**CITY OF SYRACUSE, MAYOR SHARON F. OWENS**  
**300 South State Street, Suite 700 Syracuse, NY 13202**

<b><i>R-25-34</i></b>	<b><i>Staff Report-- March 16, 2026</i></b>
<b><i>Application Type:</i></b>	Resubdivision
<b><i>Project Address:</i></b>	2956 Genesee St E (Tax ID: 042.-02-05.0), 2960 Genesee St E (Tax ID: 042.-02-06.0), 2964 Genesee St E (Tax ID: 042.-02-07.0)
<b><i>Summary of Proposed Action:</i></b>	Resubdivision application to combine three lots, 2956, 2960, and 2964 E Genesee St., into one new lot for future development of a greenhouse manufacturing facility.  Total square footage of new lot: 16,204 SF (0.372 Acres)
<b><i>Owner/Applicant</i></b>	Greater Syracuse Property Development Corporation (current owner) Ashoke Bose, SEAT, LLC (applicant)
<b><i>Existing Zone District:</i></b>	Neighborhood Center, MX-2 Zone District
<b><i>Surrounding Zone Districts:</i></b>	The neighboring properties to the north, south, and west are the High Density Residential, R5 Zone District, and to the east of the property is the MX-2 Zone District.

<b><i>SP-25-20</i></b>	<b><i>Staff Report – March 16, 2026</i></b>
<b><i>Application Type:</i></b>	Special Use Permit
<b><i>Project Address:</i

description  
SITE PLAN

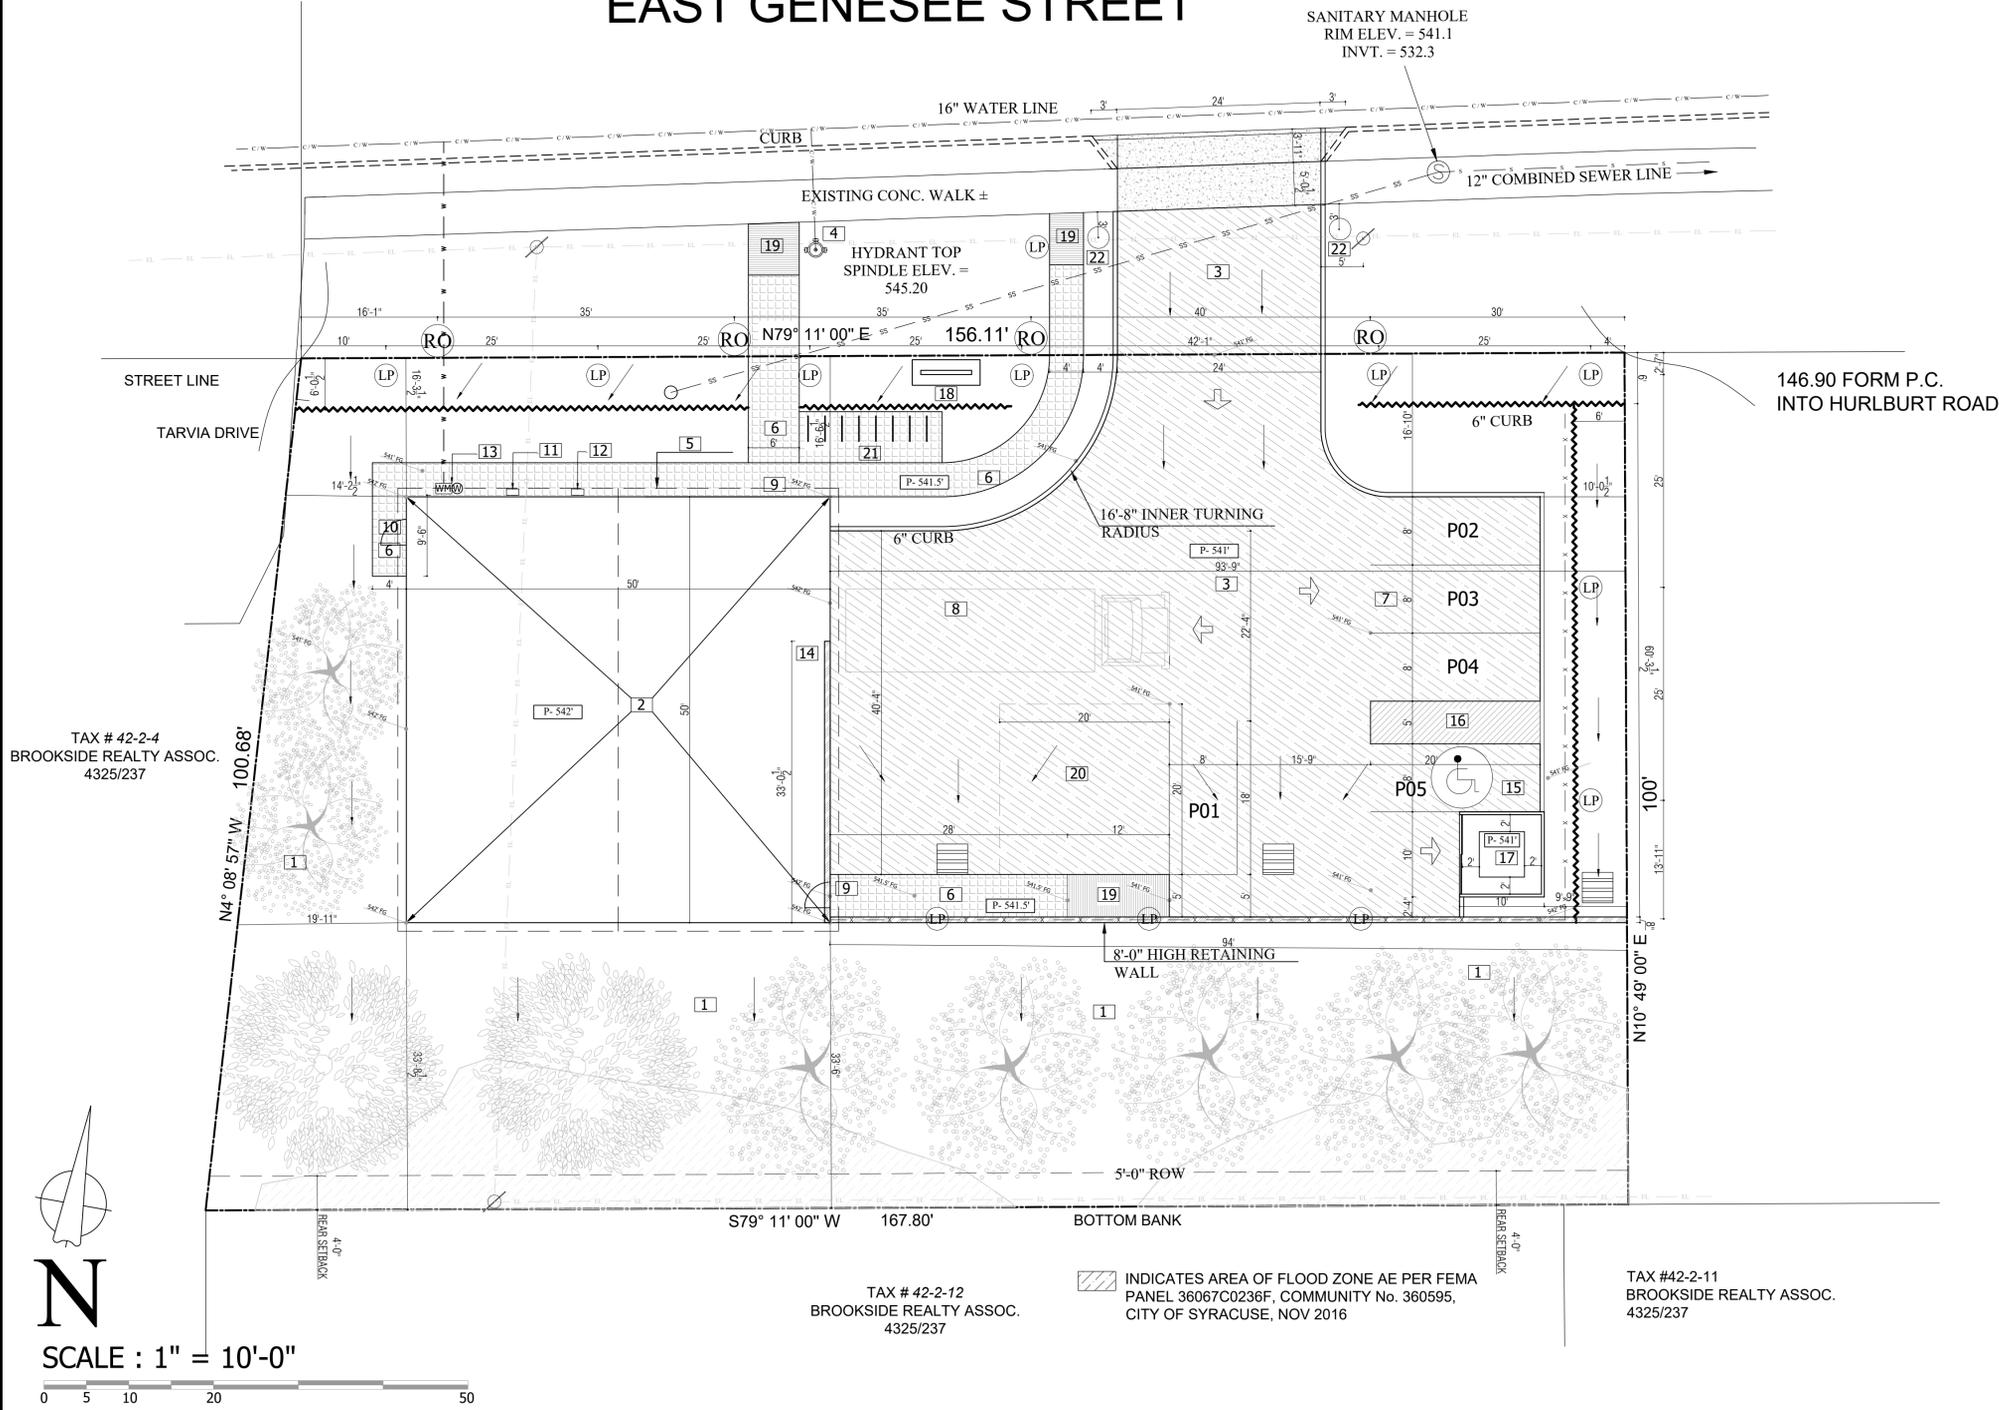
**SITE PLAN REVIEW SUMMARY**  
PER PRE-DEVELOPMENT MEETING - 05/11/2024  
**PLANNING**  
1. THE PEDESTRIAN ENTRANCE HAS BEEN RELOCATED TO THE EAST SIDE OF THE NEW BUILDING TO CLEARLY DISTINGUISH PUBLIC ACCESS TO PRIVATE SPACE.

2. COLUMNAR TREES AND HEDGES WILL BE PLANTED ALONG THE FRONTAGE TO ENHANCE THE STREETScape AND DEFINE THE SITE BOUNDARY.  
3. EXTERIOR LIGHTING HAS BEEN INCORPORATED ALONG THE PARKING LOT, DRIVEWAY AND PEDESTRIAN WALKWAYS TO ENSURE SAFETY AND VISIBILITY.

3. A GRAPHIC BAR SCALE IS INCLUDED ON THE SITE PLAN FOR PROPER SPATIAL REFERENCING.  
**ENGINEERING**  
1. TOTAL SITE DISTURBANCE IS APPROXIMATELY 8220 SQ. FT., WHICH REMAINS UNDER THE 10,000 SQ. FT. THRESHOLD.

3. VERTICAL CIRCULATION (STAIRS) CONNECTING THE 1ST AND 2ND FLOORS IS SHOWN IN THE FLOOR PLANS.  
4. RESTROOM LOCATIONS ARE INDICATED ON THE FLOOR PLANS.

5. EGRESS PATHWAYS AND REQUIREMENTS ARE ADDRESSED AND SHOWN ON THE FLOOR PLANS.  
6. THE WOODWORKING AREA IS LIMITED TO UNDER 2,500 SQ. FT., COMPLYING WITH CODE REQUIREMENTS FOR NON-SPRINKLERED AREAS.

7. THE WOODWORKING AREA IS CLEARLY IDENTIFIED ON THE 1ST FLOOR PLAN.  
8. THE BUILDING HEIGHT IS BELOW 30 FEET.  
9. A ROAD-CUT PERMIT APPLICATION WILL BE INITIATED AS REQUIRED.

**PARKS DEPARTMENT**  
1. TO ENHANCE THE PUBLIC REALM, KINDRED SPIRIT OAK TREES WILL BE PLANTED. THESE ARE UPRIGHT, COLUMNAR TREES KNOWN FOR THEIR NARROW FORM (~30 FT TALL x 6 FT WIDE), DISTINCTIVE SILVER LEAF UNDERSIDES, AND TIGHT BRANCHING—IDEAL FOR URBAN STREETScape IMPROVEMENT.

**DPW TRANSPORTATION PLANNER REVIEW SUMMARY**  
1. THE CURB OPENING HAS BEEN REDUCED TO 24 FEET WITH A TRANSITION CURB SECTION, TOTALING 6 FEET. NYS DOT TYPE 3 CURB CUT DETAIL SPECIFICATIONS WILL BE IMPLEMENTED FOR THIS CONFIGURATION.  
2. THE SIDEWALK ADJACENT TO THE DRIVE AISLE HAS BEEN RELOCATED 4 FEET AWAY FROM THE DRIVE AISLE EDGE. THE SIDEWALK WIDTH HAS BEEN REDUCED FROM ITS PREVIOUS DIMENSION TO 4 FEET.  
3. EXISTING WHEEL STOPS HAVE BEEN REMOVED AND REPLACED WITH CONTINUOUS CURBING ALONG BOTH THE PARKING LOT AND DRIVE AISLE AREAS.  
4. A STOP SIGN HAS BEEN INSTALLED.  
5. A NEW BICYCLE PARKING AREA FEATURING STAPLE-STYLE RACKS HAS BEEN INSTALLED ADJACENT TO THE MAIN ENTRANCE.

Concrete Base For SGH

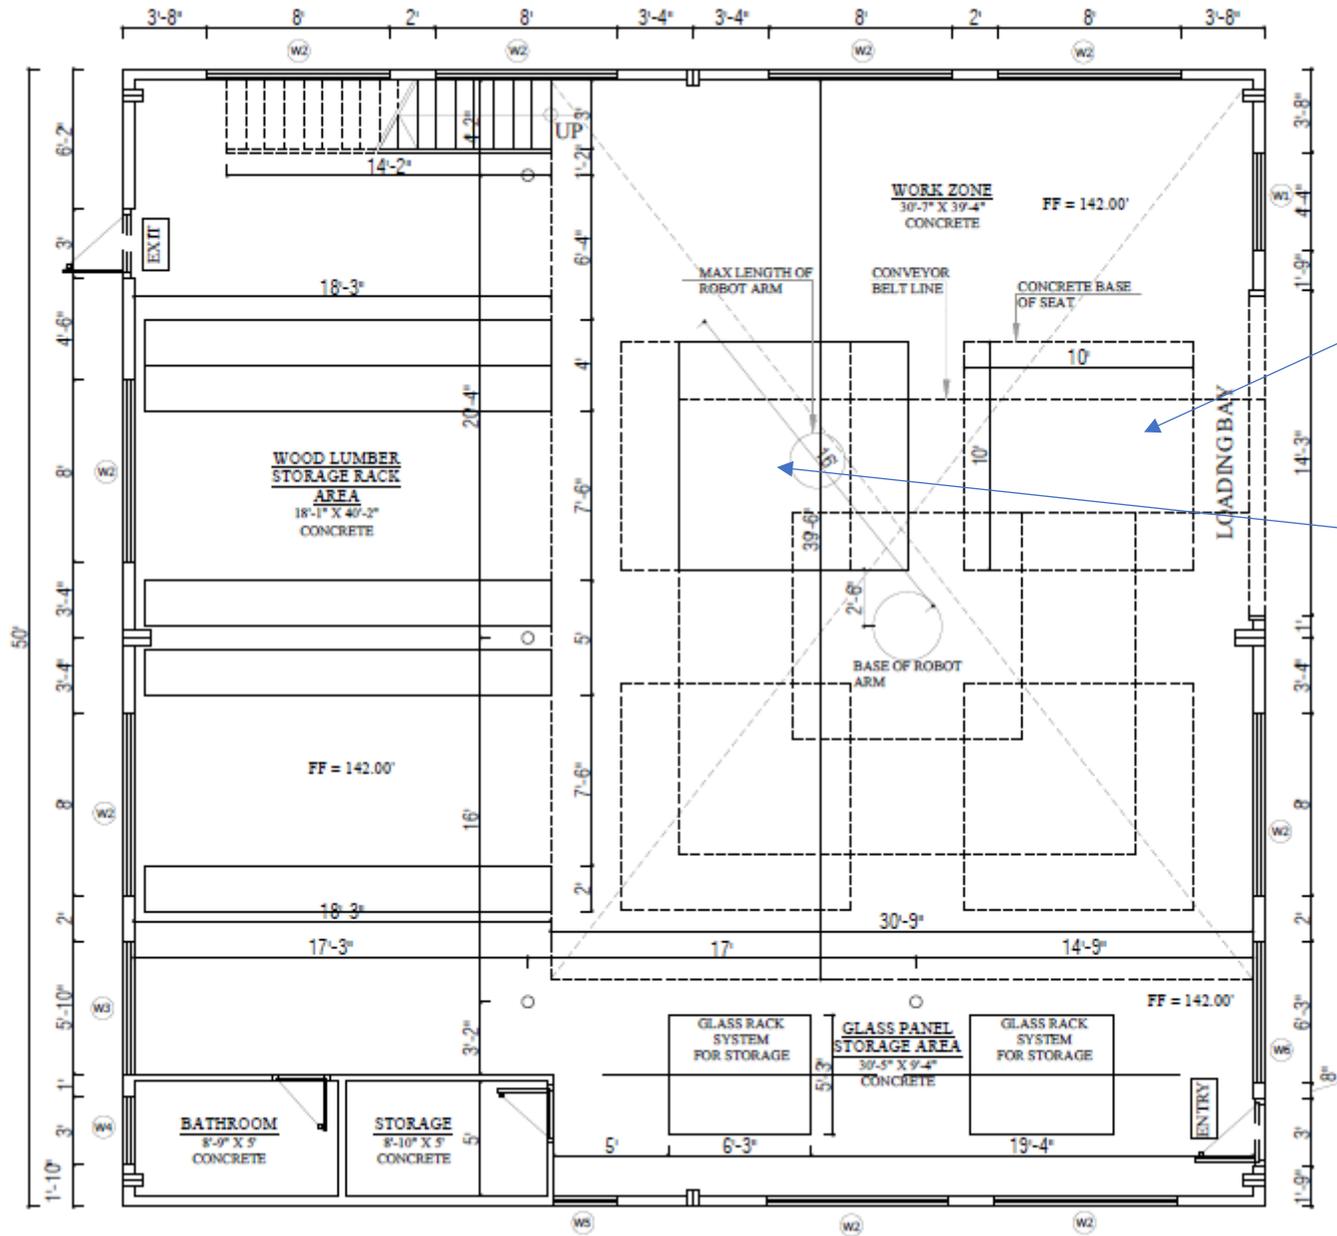
Corrected on 6/6/2024  
 R was 26' based on  $200 \cdot D$   
 R is 16'
